## RV-6A Elastomer Mount WARNING

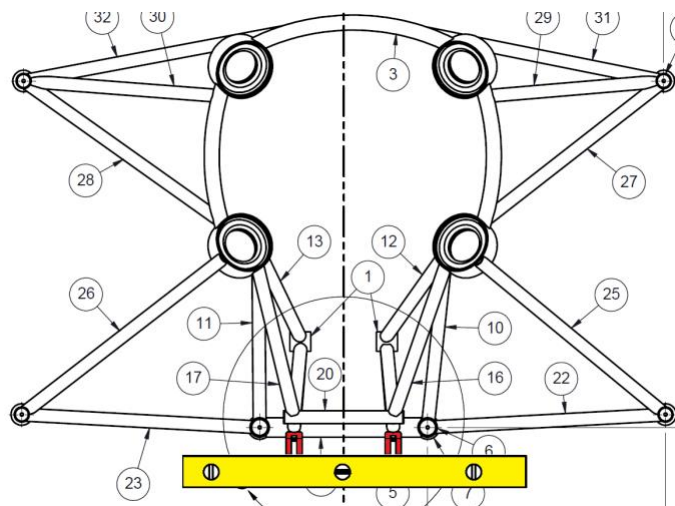
Van's Aircraft has not installed an Elastomer style engine mount on a RV-6A airframe. Those considering this should first, read "Retrofit Considerations" detailed in [SL 19-04-30 - Van's Aircraft Total Performance RV Kit Planes \[vansaircraft.com\]](#). RV-6A additional considerations detailed below. Weight and balance changes on the RV-6A may be more significant than that of the RV-7A and RV-9A. The new elastomer style mount may move the engine up to (but not limited to) one inch further forward than the original RV-6A engine mounts. There is potential that ballast may be needed to ensure aircraft remains within designed CG limits.

The cowling will likely not fit due to the new mount moving the engine up to (but not limited to) one inch further forward than the original RV-6A engine mounts. The original cowling can be modified to work but this will be labor intensive. Some builders may find it easier to start with a new cowling.

Early RV-6A airframes without pre-punched firewalls will require emphasis and concentration on the drilling of the center two mounting holes in the new mount first. Centering of these two holes is required to be accurate as tightening of the associated bolts requires the insertion of a 1/2" socket into the base of the mount. The mount must also be leveled between the gear leg lugs and longerons to ensure the mount and nose gear are properly oriented to the airframe.

Please note that you should substitute the **U-00020-250-PC** for the **U-00020-PC** in the **7A/9A DYNALMNT KIT RETRO** if installing on an RV-6A.
